**FINAL EXPRESS TERMS
FOR
PROPOSED BUILDING STANDARDS
OF THE
DEPARTMENT OF HOUSING AND COMMUNITY DEVELOPMENT
REGARDING THE ADOPTION BY REFERENCE OF THE
2009 INTERNATIONAL BUILDING CODE (IBC) WITH PROPOSED AMENDMENTS INTO THE
2010 CALIFORNIA BUILDING CODE (CBC)
CALIFORNIA CODE OF REGULATIONS, TITLE 24, PART 2
[ACCESSIBILITY AND ACCESSIBILITY-RELATED STANDARDS ONLY]
(HCD 01/09)**

The Department of Housing and Community Development (HCD) proposes to adopt the 2009 edition of the International Building Code (IBC) for codification and effectiveness into the 2010 edition of the California Building Code (CBC) as presented on the following pages, including any necessary amendments. HCD further proposes to:

FIGURE 11A-4B 1E—MINIMUM CLEAR WIDTH FOR TWO WHEELCHAIRS

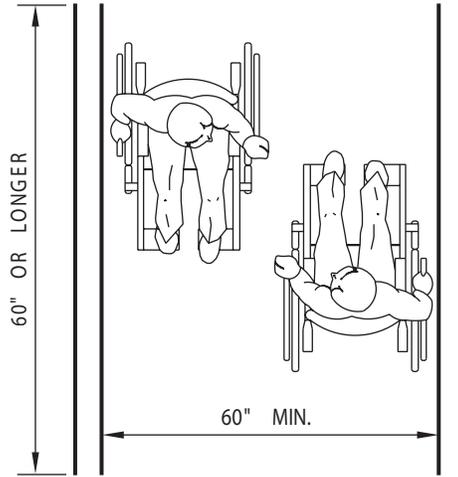
FIGURE 11A-1D – MINIMUM CLEAR WIDTH FOR TWO WHEELCHAIRS

Correct figure number of top right figure to "FIGURE 11A-1F."

FIGURE 11A-11—FORWARD REACH

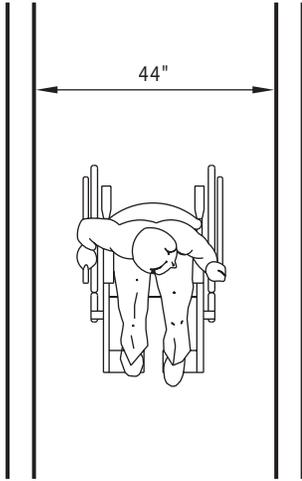
FIGURE 11A-1I – FORWARD REACH

FIGURE 11A-1L—CORRIDOR OVER 200 FEET (60 960 mm)

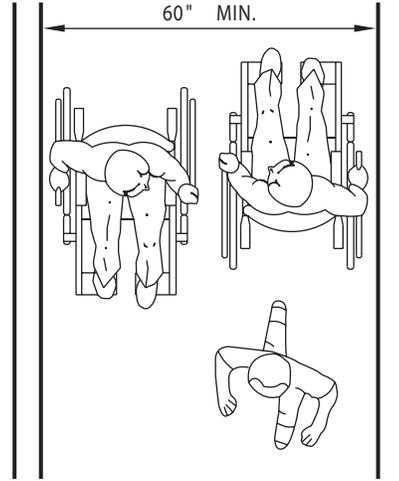
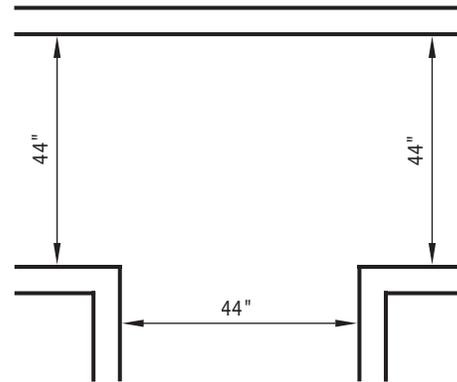
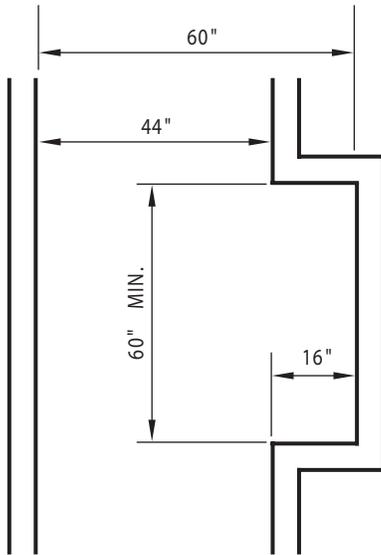
FIGURE 11A-1L – CORRIDOR OVER 200 FEET (60 960 mm)

FIGURE 11A-2B—DIAGONAL SINGLE AND VAN ACCESSIBLE PARKING STALLS

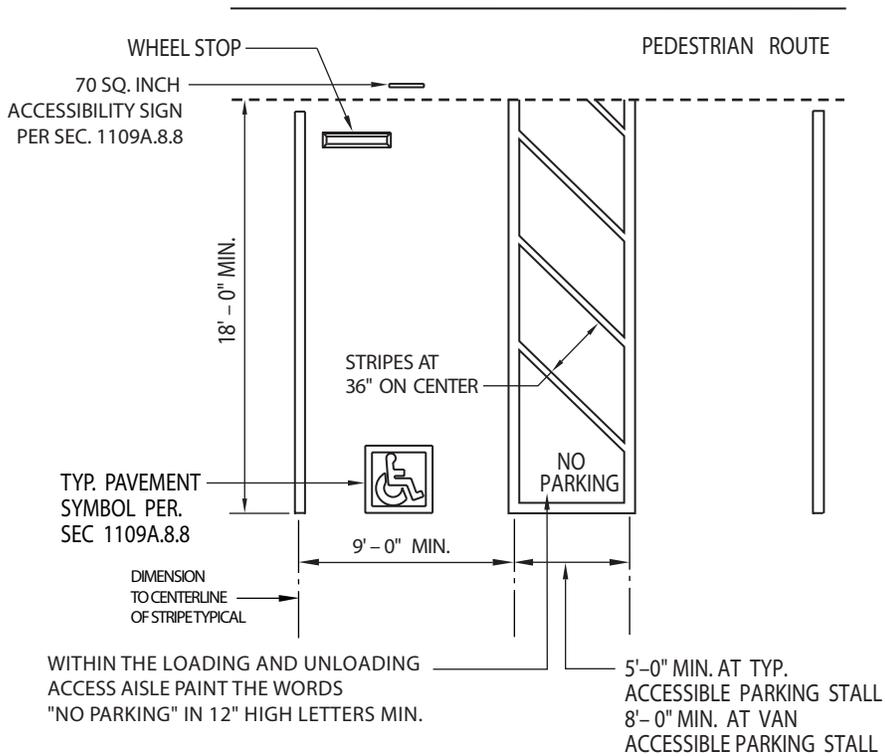
FIGURE 11A-2B – ~~DIAGONAL PARKING STALLS~~ SINGLE AND VAN ACCESSIBLE PARKING STALLS

FIGURE 11A-3E—CURB DETAIL

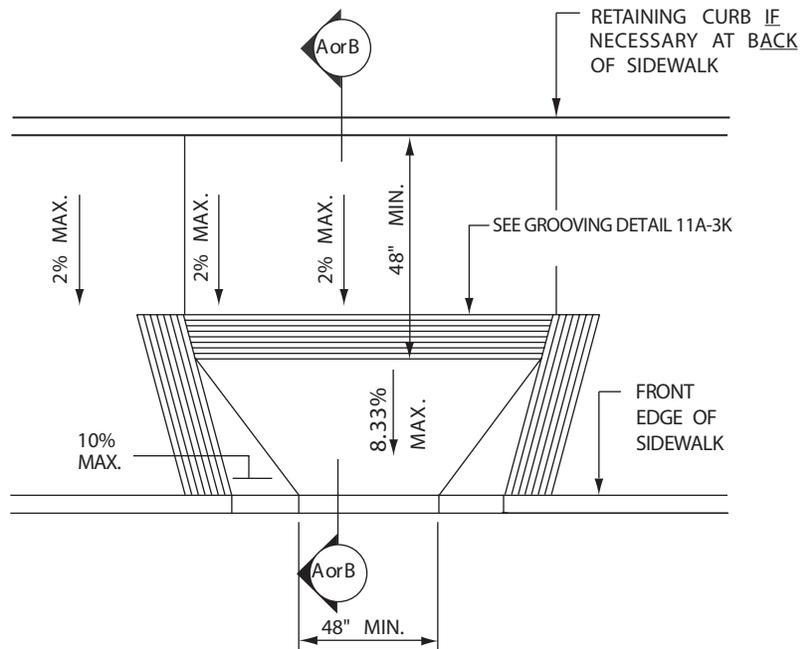
FIGURE 11A-3E – CURB DETAIL

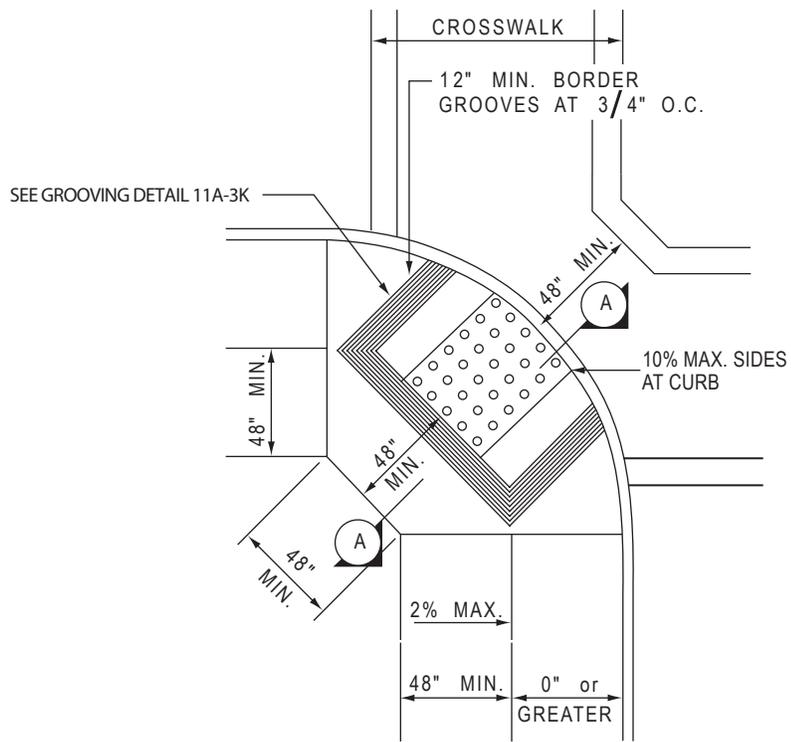
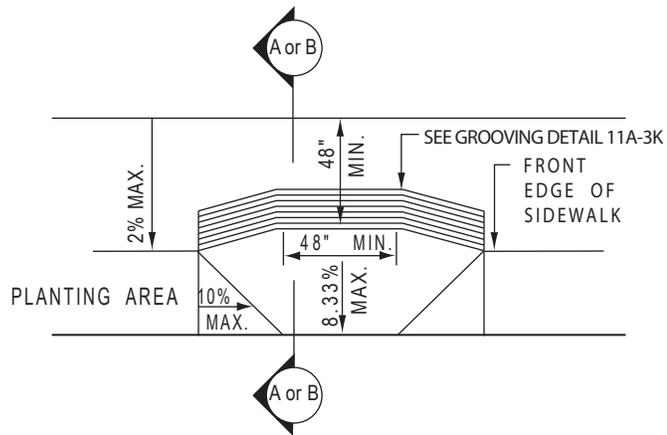
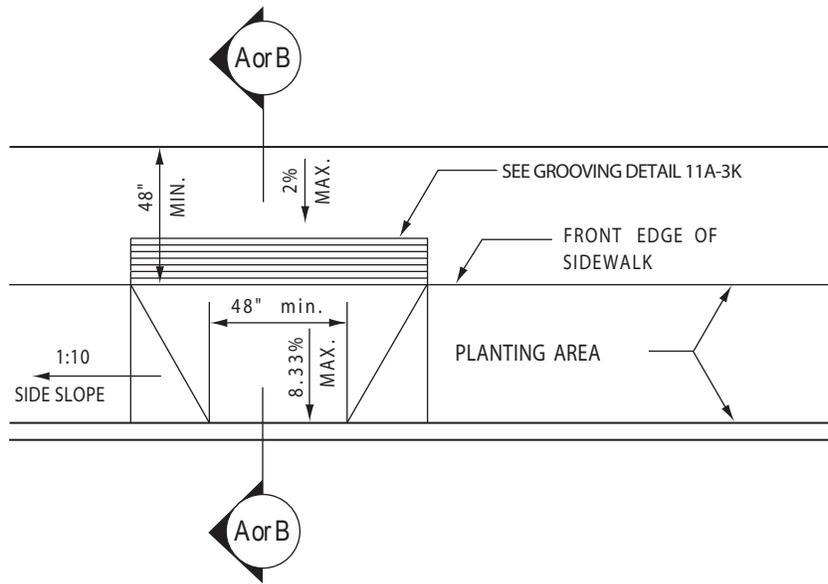
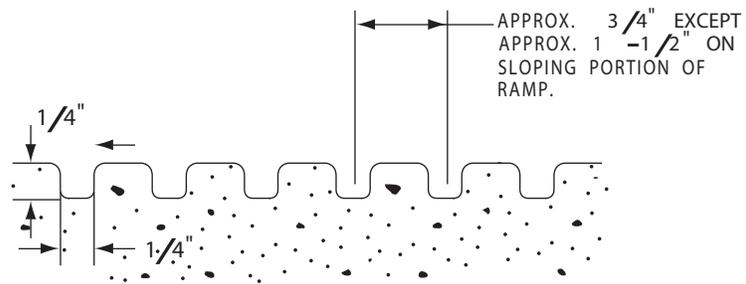
FIGURE 11A-3H/FIGURE 11A-3I and FIGURE 11A-3J/FIGURE 11A-3K.

Reverse order of pages to keep figures in correct sequence.

FIGURE 11A-6B—STAIR HANDRAILS

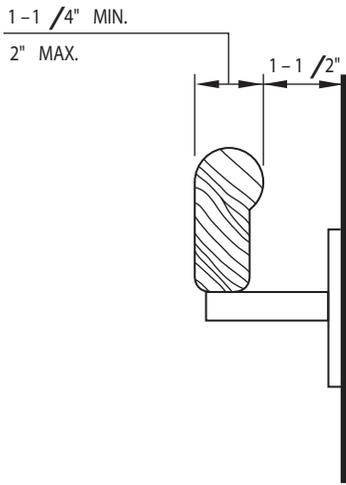
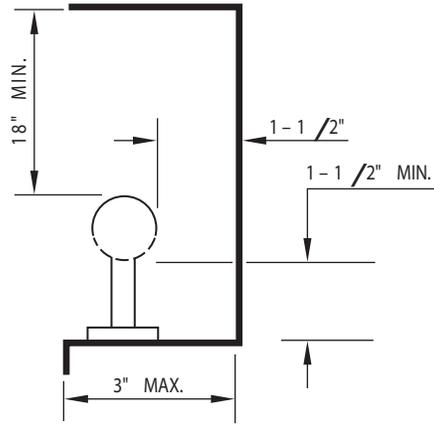
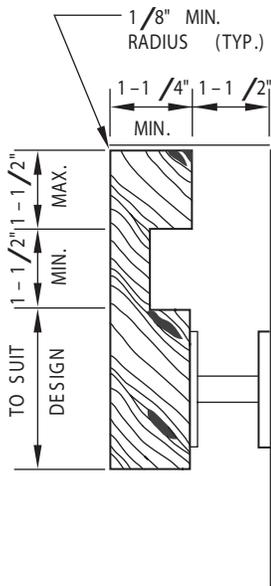
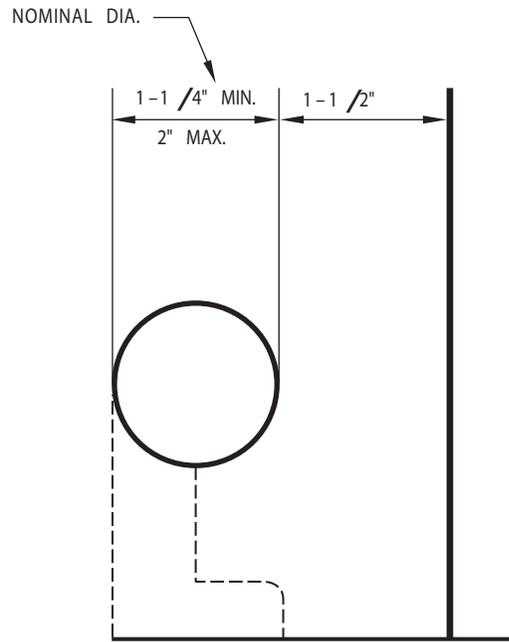
FIGURE 11A-6B – STAIR HANDRAILS

Delete extraneous reference to "18" MIN." between top two figures.

FIGURE 11A-7B—ELEVATOR CONTROL PANEL

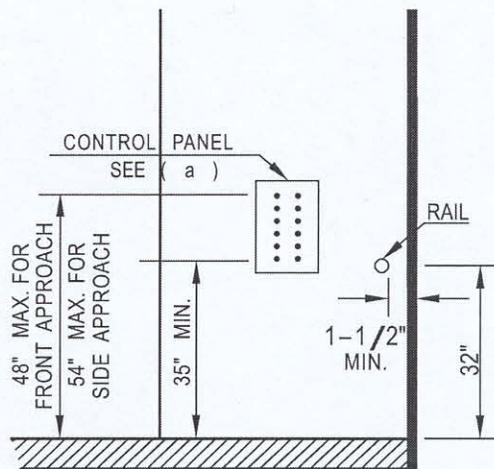
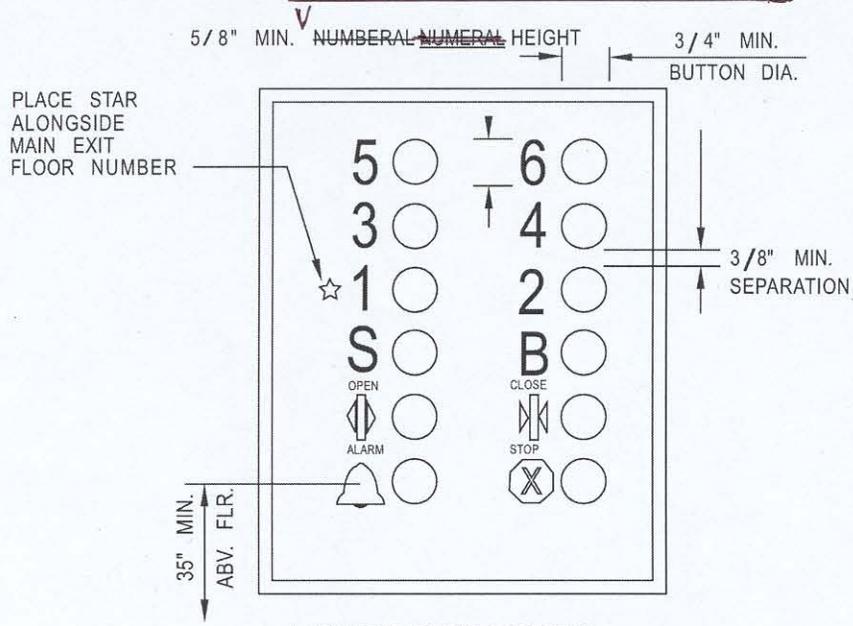
FIGURE 11A-7B – ELEVATOR CONTROL PANEL

Correct spelling of "numeral" at top of figure.

FIGURE 11A-8B—HINGE SIDE APPROACHES - SWINGING SWINGING DOORS

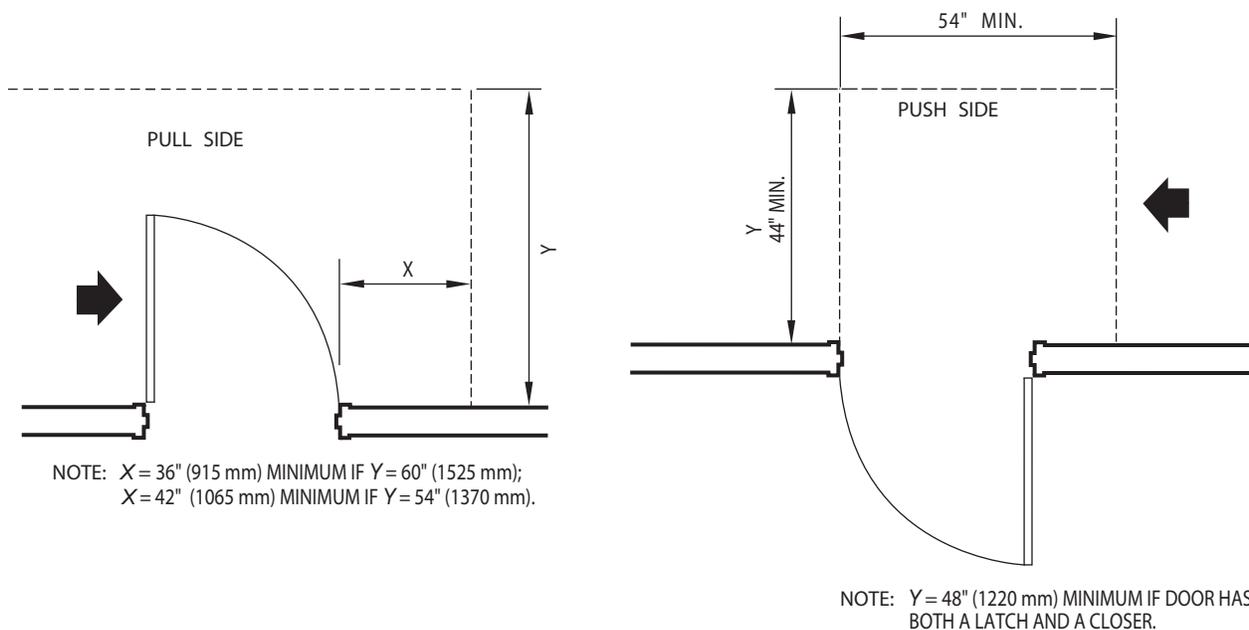
FIGURE 11A-8B – HINGE SIDE APPROACHES – SWINGING DOORS

Correct spelling of "swinging" in figure title.
